REQUEST FOR PROPOSAL

Project Title: Cooley Laboratory Renovation
Location: Montana State University

PPA No.: 10-0023
RFP No.: 19
Date: 12/21/11

RFP -Revise Wall Types @ Basement Corridor & Elevator Addition

A1.5

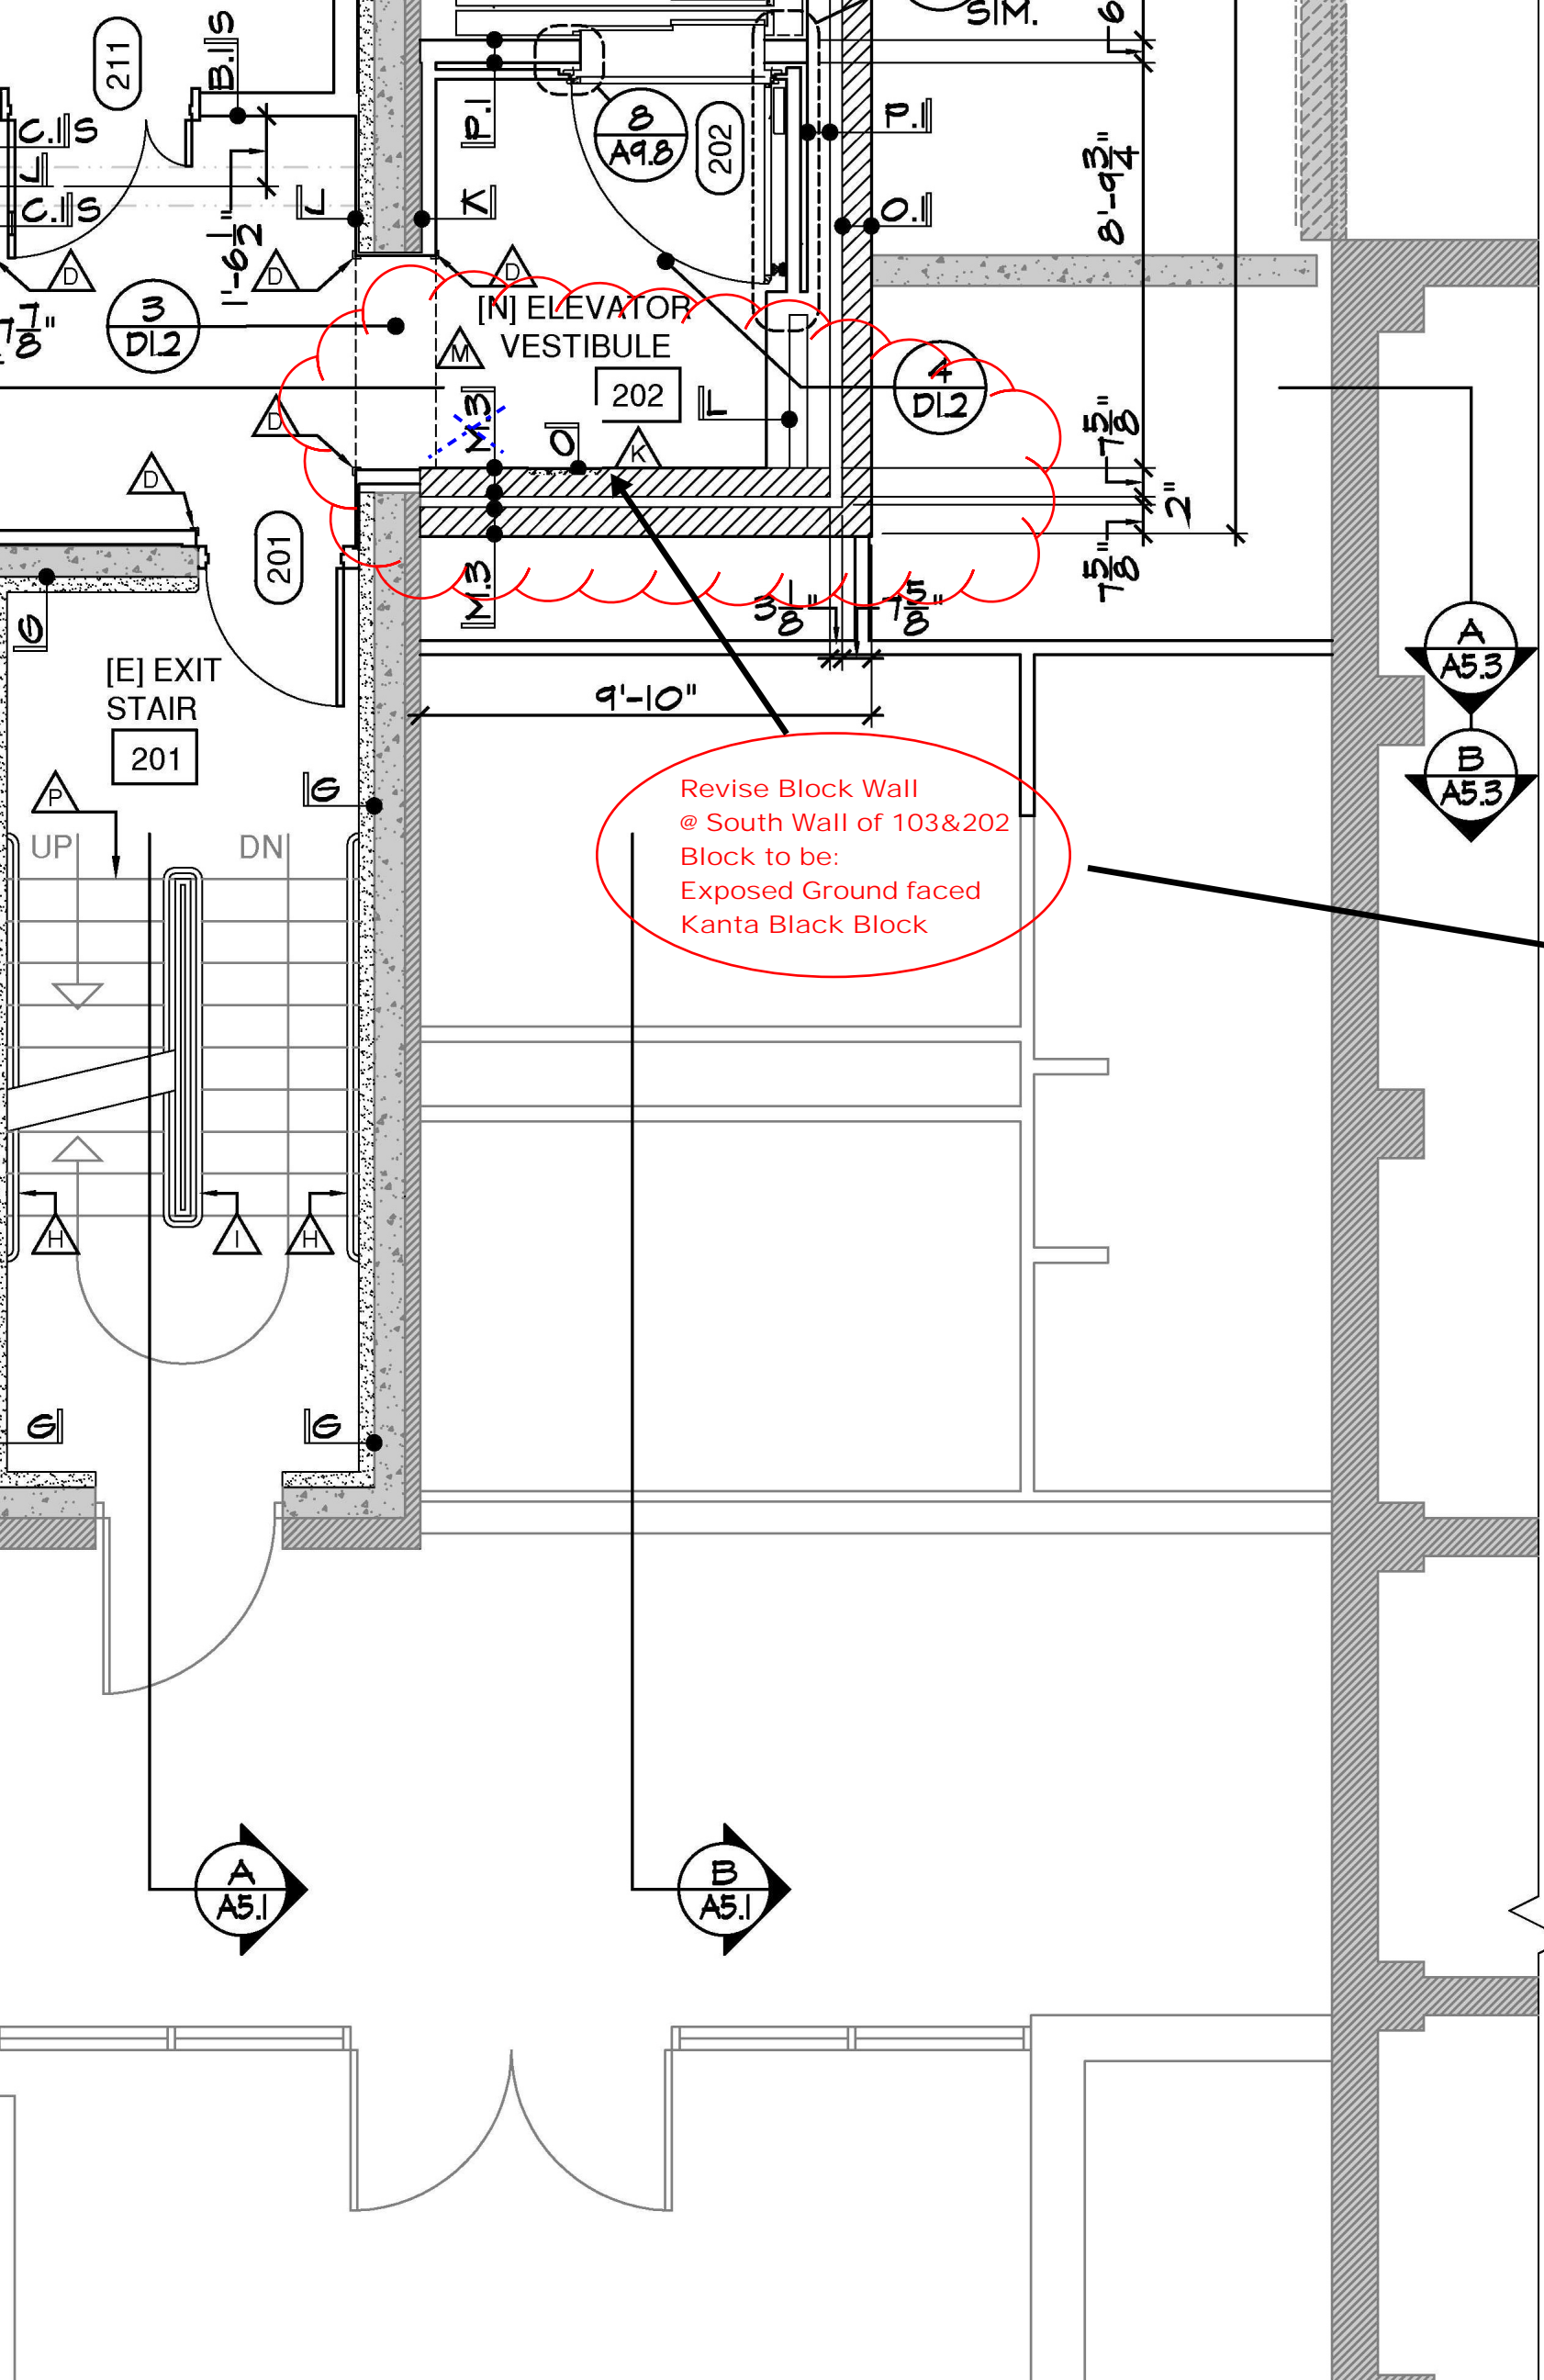
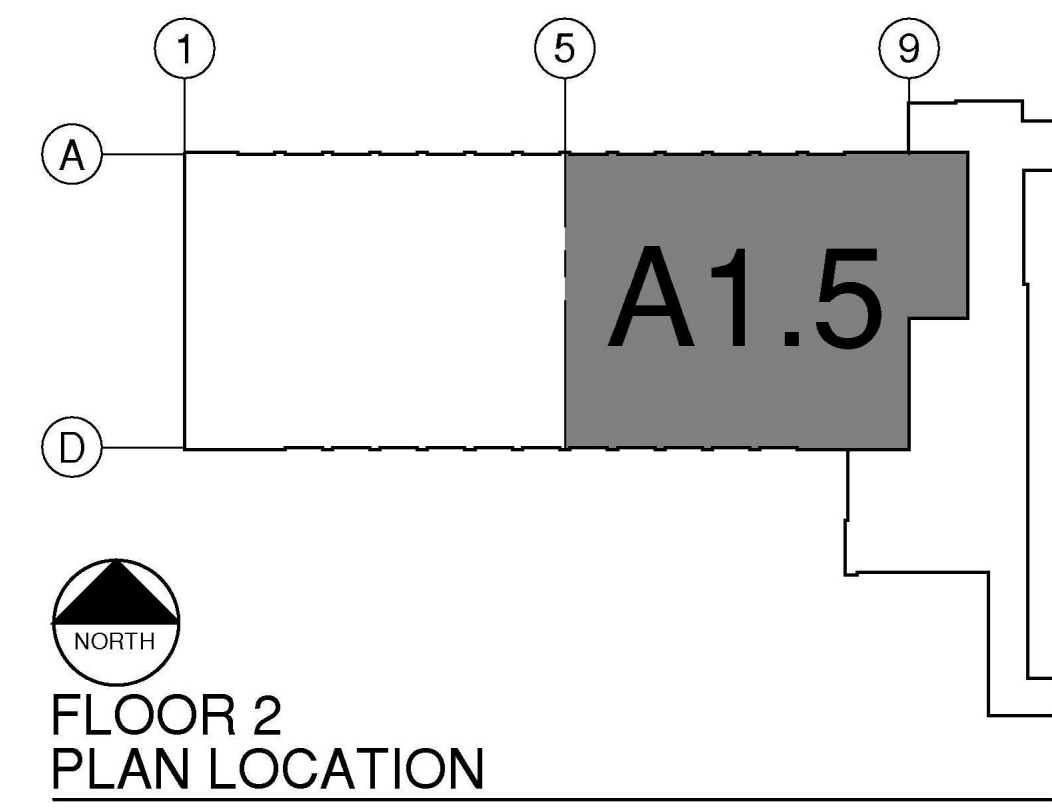
Revise CMU Block Wall Types as shown on the attached drawing:

1. Basement Corridor; Replace two(2) sections of gray block designated wall type (O) with 8" Ground Faced Block "Kanta Black" wall type (O.1) To accomodate Electrical Panels located along those walls.
2. Remove North Wall of Vestibule 004 and Replace with 8" Ground Faced Block " Kanta Black" as shown on RFP19-1
3. Replace 6" Block designated wall type M or M.1 (Normal Color) with Block designated wall type O " Kanta Black" locations as noted on attachment RFP19-1
4. Revise South Wall of elevator vestibule 103 from wall type M3.1 to O.1
5. Revise South Wall of elevator vestibule 202 from wall type M3.1 to O.1

**REVISE LOCATIONS NOTED FOR 8" or 6" GROUND FACE
 CMU "COLOR - (KANTA BLACK)
 WALL TYPE noted as O.1 = 8" WALL TYPE O = 6"**
